Staff Report & Recommendation

Design Review Board

SUBJECT: DRB19-0446
6494 Allison Road

DRB19-0446, 6494 Allison Road. An application has been filed requesting Design Review Approval for the construction of a new two-story single-family residence to replace an existing two-story architecturally significant pre-1942 residence including one or more waivers.

North elevation of the neighboring property @ 6480 Allison Road, permit B1403166

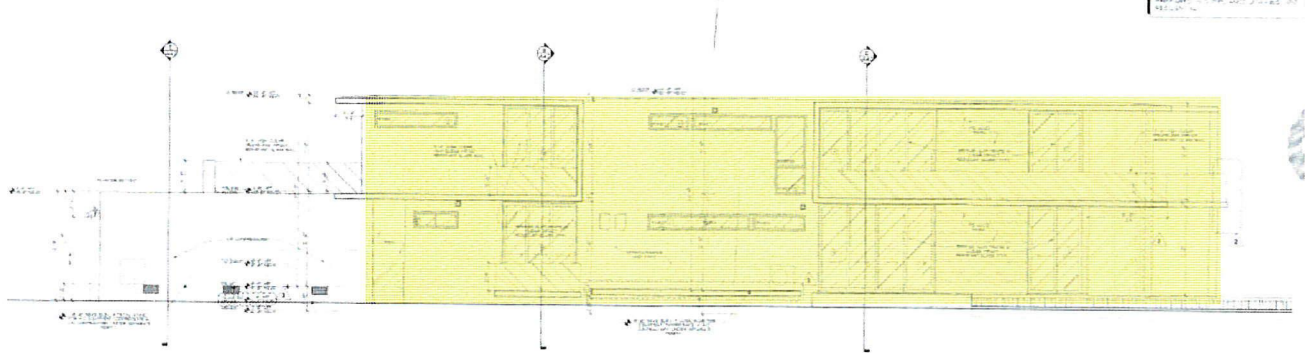
The south elevation has a ground floor component that extends 89'-4" while the second floor elevation, with its cantilevered elements, extends 106'-10" without incorporating additional open space or any architectural relief. As proposed the second floor massing has been designed with solid panels of concrete and no fenestration. One second floor outdoor patio has been provided that measures 14'-0" wide in an attempt to break up the uninterrupted nature of the elevation. The abutting property to the south, was built in 2017, and reviewed and approved by the DRB on June 3, 2014, pursuant to DRB File No. 23034.

In this regard, the proposed new home would "align" with the 93'-0" long two-story elevation that was granted a waiver of the required open space by the DRB in 2014. The neighboring property to the south is the only property that would be impacted by the requested waiver. Therefore, the proposed uninterrupted two-story elevation will align with the built condition of the neighboring property. In this instance, staff is supportive of the design waiver along the south side elevation, as it would not have an adverse impact on the neighboring property. Staff is supportive of the two design waivers contingent on the recommended modifications, in order to assure the waivers will not have an adverse impact on the neighboring property and the intent and spirit of the ordinance is maintained.
